# HISTORIC LANDMARK COMMISSION STAFF REPORT

## Trolley Square New Construction Petition 470-07-21: Amending the previously approved design of Building C 602 East 500 South November 5, 2008

Trolley Square Permit Plan Review: Building C Whole Foods  
October 15, 2008

# WHOLE FOODS - ELEVATIONS

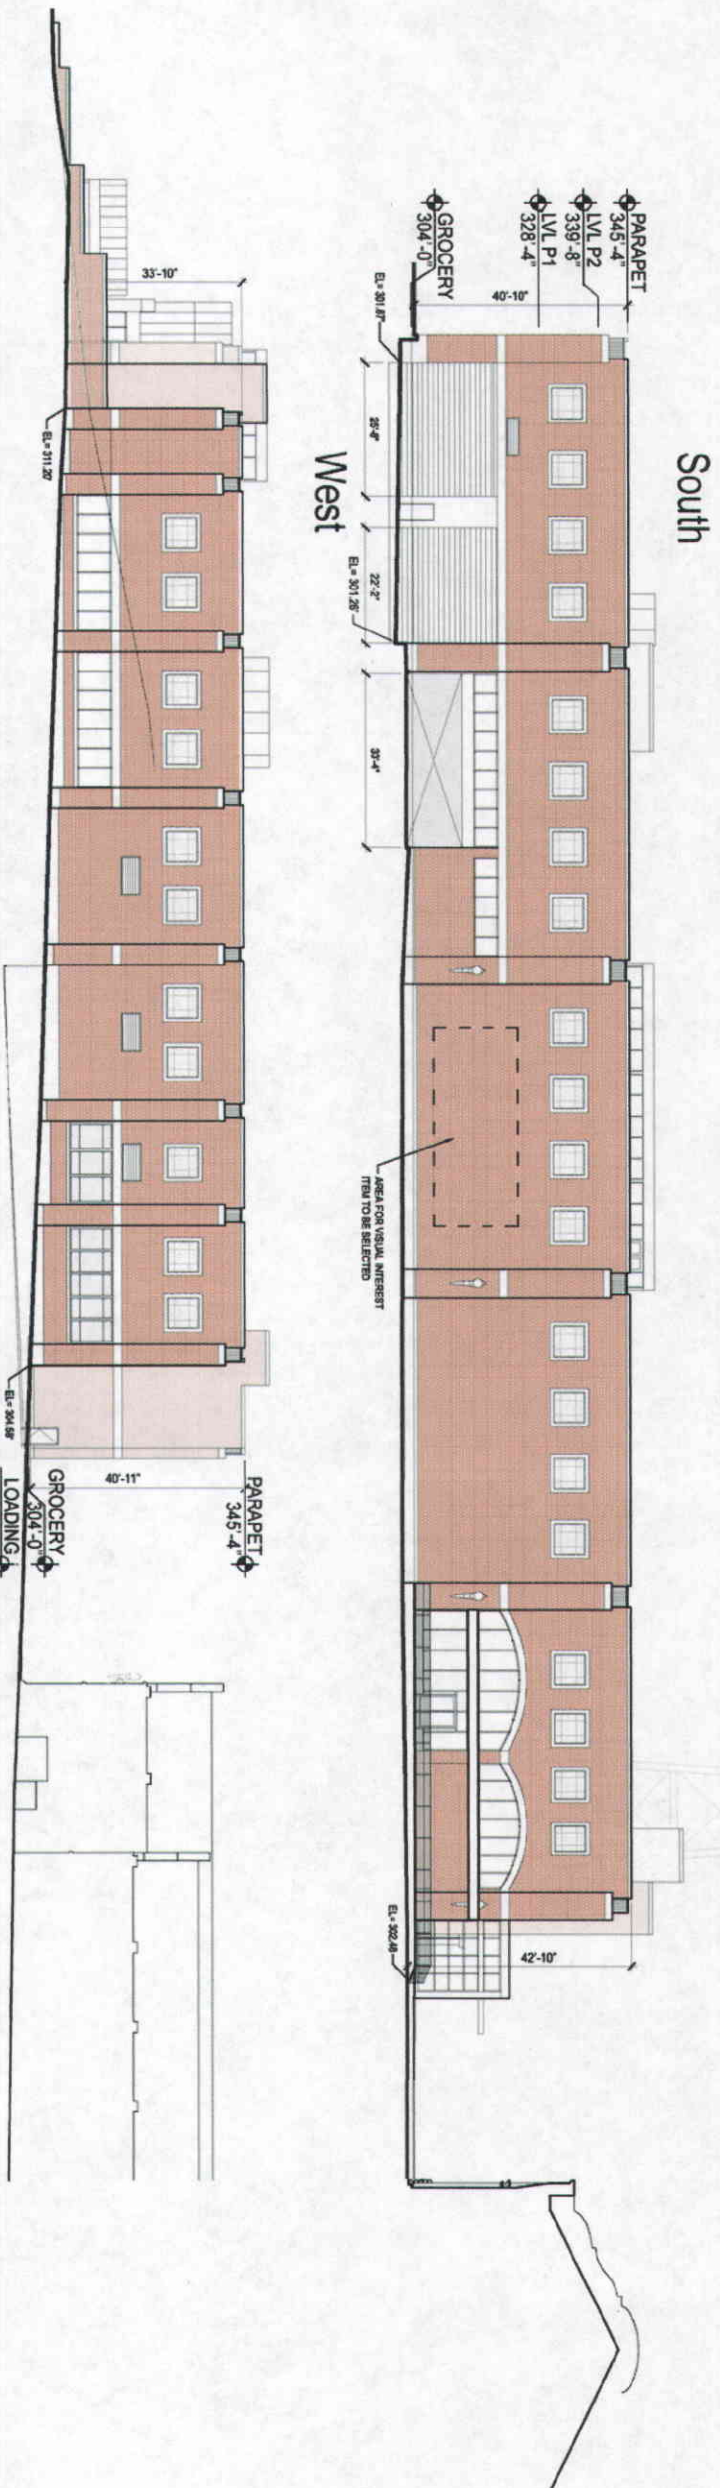
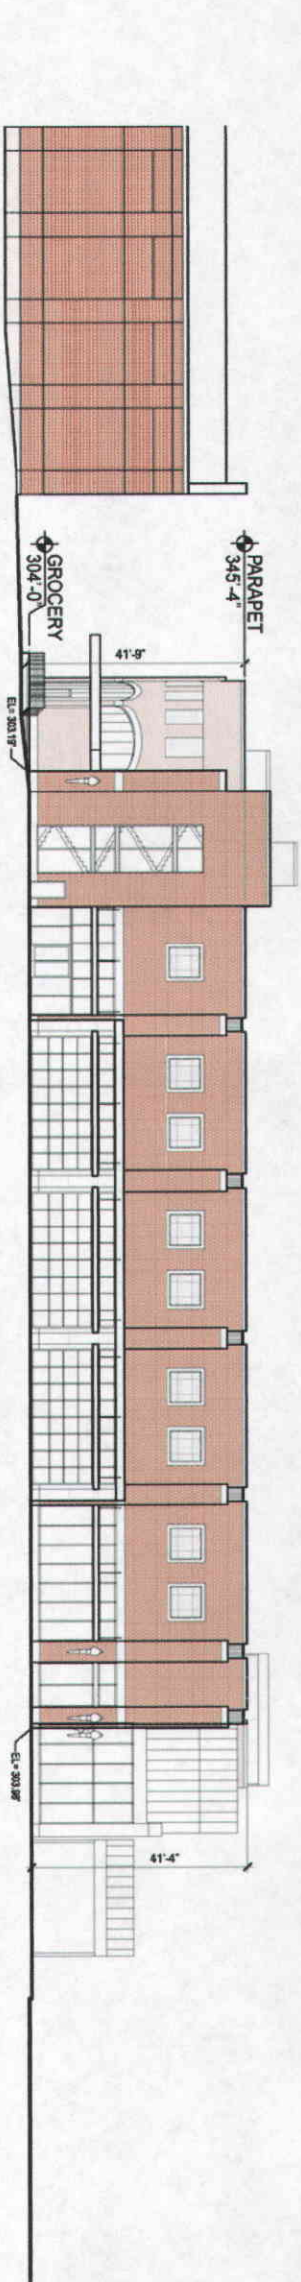
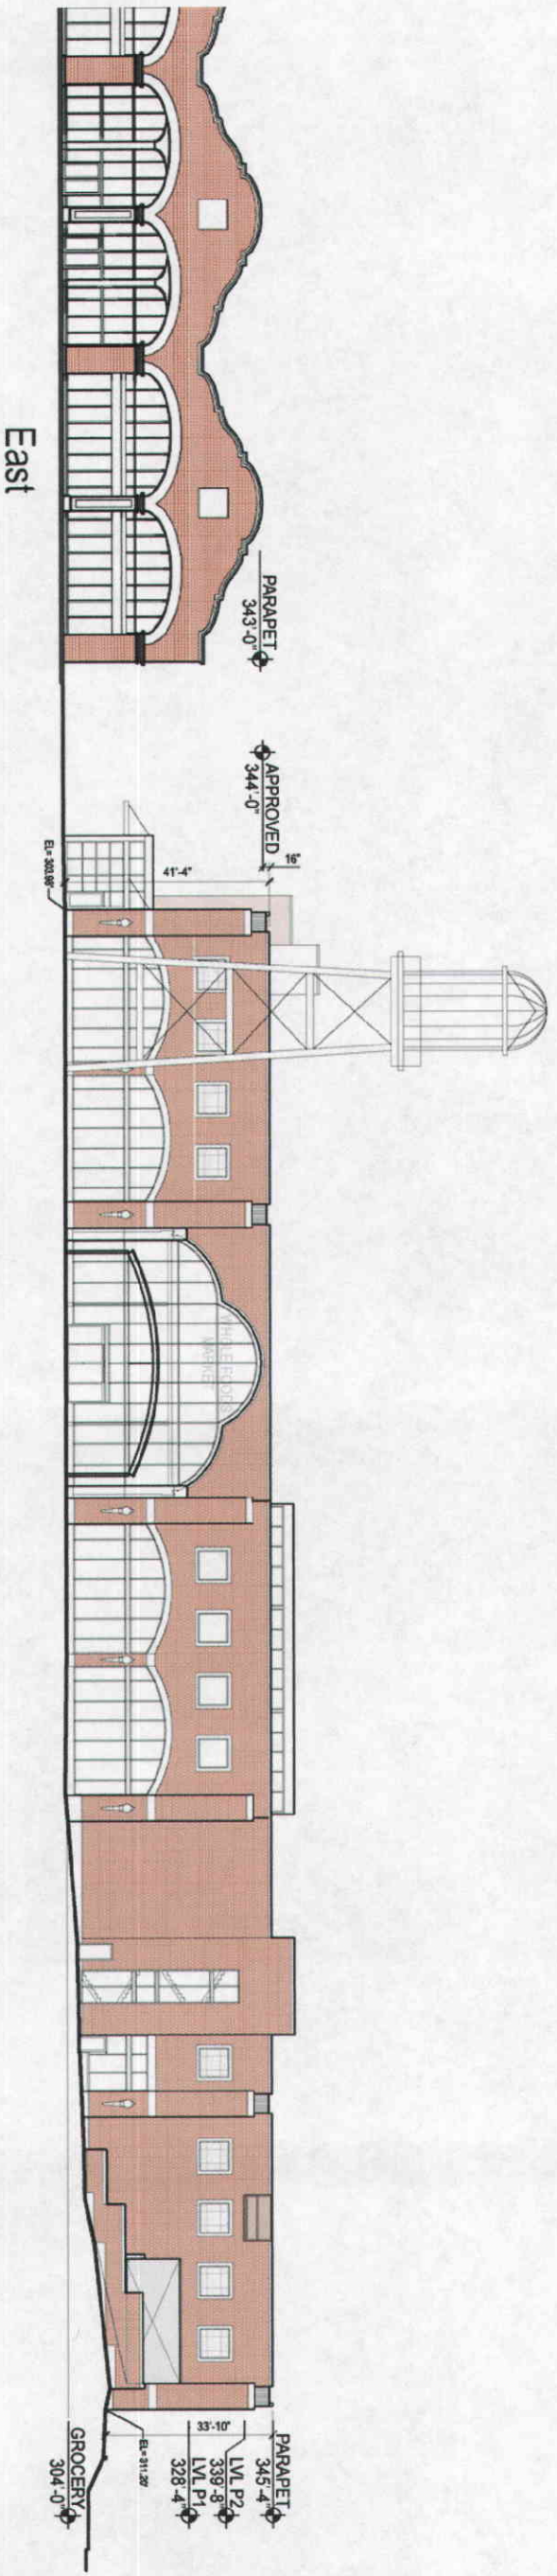
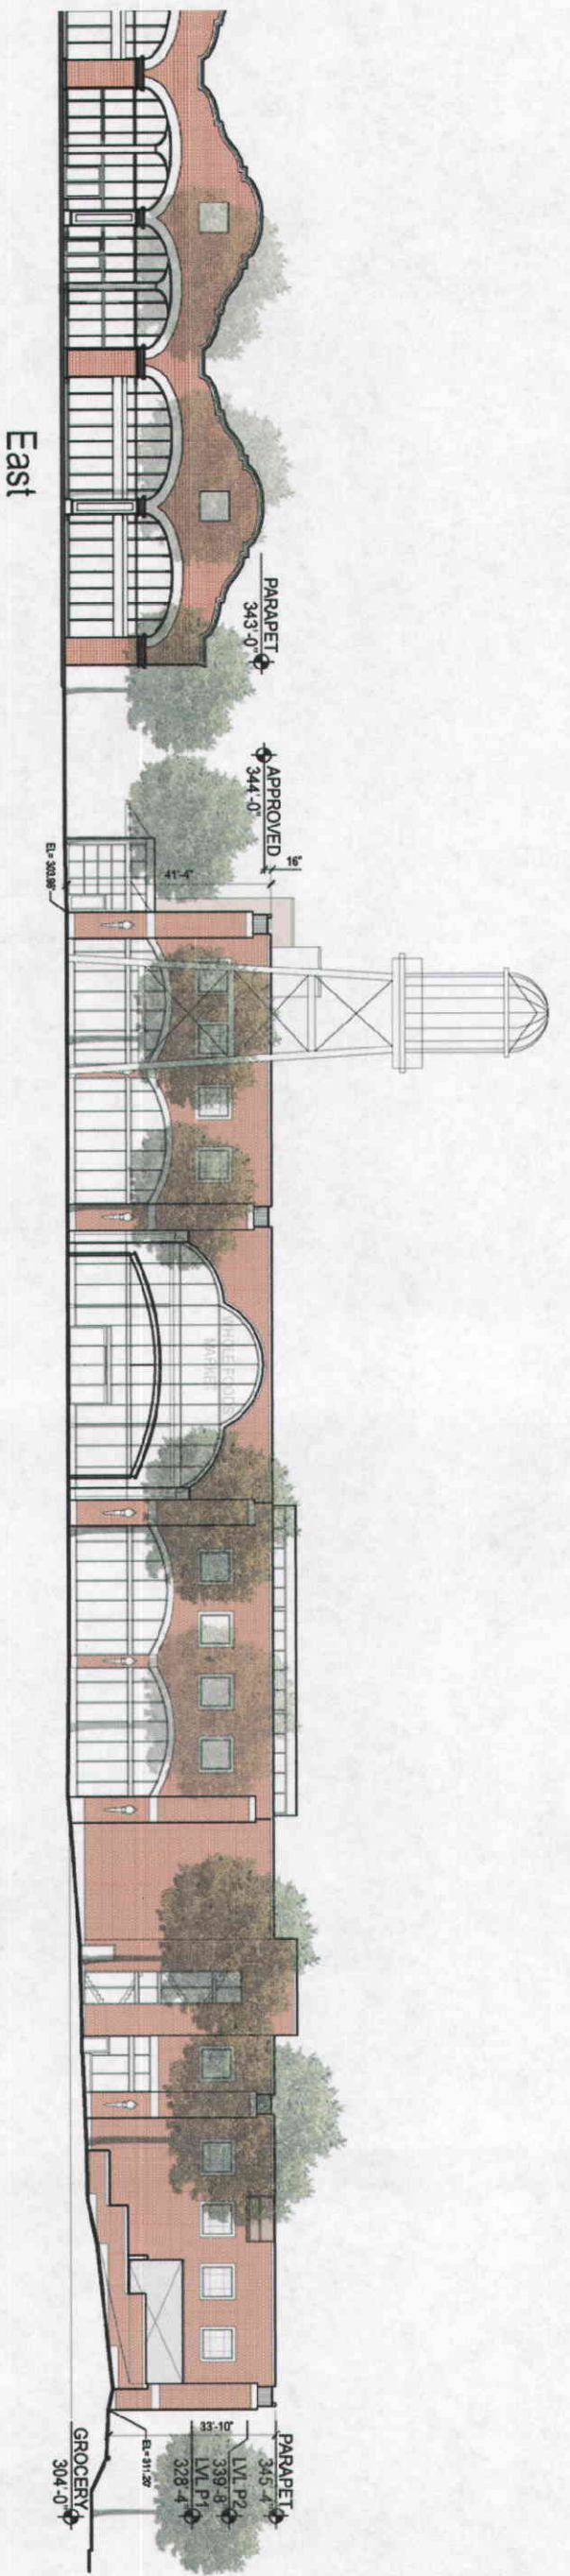
1. That the blank wall section of the east elevation includes second level cutouts and that the banding above the storefronts is connected to the storefront on the north side of the stair well.
2. That the southern wall section on the west elevation include a store front that matches the adjacent store front to the north.

The proposed east elevation of Building C includes reducing the amount of window bays. The approved elevations show 4 window bays on the north side of the primary entrance. The proposed design includes two

window bays and adds an internal staircase. One window bay was removed to accommodate a shear wall, which is required to insure structural integrity. The staircase does include glass that extends up to the second level and glass doors at the ground level. The primary entrance has a different design. The approved design included a flat canopy over the entrance, while the proposed design includes an arched canopy that appears to extend further from the building. The number of square cut-outs on the second parking level has increased on the proposed drawings. The east elevation contains three sections with 4 cut-outs per section and one section with one cut-out due to the location of the stair. The cutouts contain a wire grill to improve safety.

The south elevation was approved with a series of six storefronts, four of which contained overhead glass doors that opened up to a covered patio that provided outdoor seating. The proposed elevations include three overhead glass doors with an enclosed porch and two glass storefronts. The sixth storefront has been replaced with a stair tower. The stair tower was shown on the southwest corner of the approved plans. The applicants are proposing to relocate the stair tower to the east along the south elevation. The south elevation includes six wall sections with two cut-outs per section for ventilation to the second level parking. The cut-outs include a metal grill to improve safety.

The west elevation was approved with a glass entrance to a stair tower and a glass storefront on the southern corner. The proposed elevation alters this elevation by relocating the stair tower and curving the wall. The glass storefront is still located in approximately the same location, with the corner glass area now bricked in with an arched window band above it. Further to the north, the entrance to the parking has been widened to allow for a proper turning radius to the parking ramp. The arched windows above the parking entrance have been changed to a rectangular band. The entrance to the loading area has been altered by eliminating the arched windows above the overhead doors. The west elevation includes five wall sections that each contains a series of 4 cut-outs for the second level parking area. The cut-outs include a metal grill to improve safety.

The proposed north elevation was divided into 6 sections, with four of the sections containing ground level storefronts. The proposed elevations have eliminated the storefronts that were located in the loading dock area and replaced them with a screen opening in one of the sections. Ventilation grills have been added for the second level parking area. The number of cut-outs to the second level parking area has been increased to two per wall section. One wall section has been reduced in width due to the required length of the loading dock. This section contains one cut-out. All cut-outs contain a metal grill for safety.

**DISCUSSION:** The east elevation of Building D has a number of openings that were designed to allow trolley cars to enter the building. Those openings have been converted to store fronts. The existing store fronts typically contain a knee wall and a display window. This basic storefront design is similar to other commercial buildings in the Central City Historic District. The proposed alterations to Building C reduce the amount of glass storefronts on the northern half of the east elevation. The result is that the northern half

The west elevation includes a reduction in the number of openings. The applicants are proposing to eliminate the window opening above the loading dock doors and changing the shape of the windows above the parking ramp entrance. The approved elevations included two bays of arched windows, one directly above the parking entrance and one directly south of the parking entrance. The proposed windows are rectangular and extend above the opening and continue across the wall section. The southern portion of the west elevation has been redesigned by relocating the stair well and altering the design of the openings. The corner area includes an arched opening above an area that could be storefront. In order to maintain the rhythm of grouping two arched storefronts together, the bricked in area below the arched opening should be converted to storefront.

The approved design of the South elevation contains six wall sections with each section containing a glass store front. The middle section of the approved south elevation contains a covered patio. The proposed changes enclose the patio area with glass as the primary material and include three overhead doors to open the patio in good weather. The changes reduce the number of storefronts from six to five. This is to accommodate the stair well, which is being relocated from the west elevation to the south elevation. The changes to the south elevation do not negatively impact the composition of the façade.

**FINDING:** The composition of the principal facades of the proposed changes to Building C are not visually compatible with the adjacent buildings or the streetscape. Specifically, the east elevation reduces the number of openings on the ground level in a manner that is not compatible with the design of Building D. This results in the building not being visually compatible with the streetscape. By placing the cutouts in the second level of the blank wall sections and continuing the banding above the store fronts, the rhythm of the east elevation is improved.
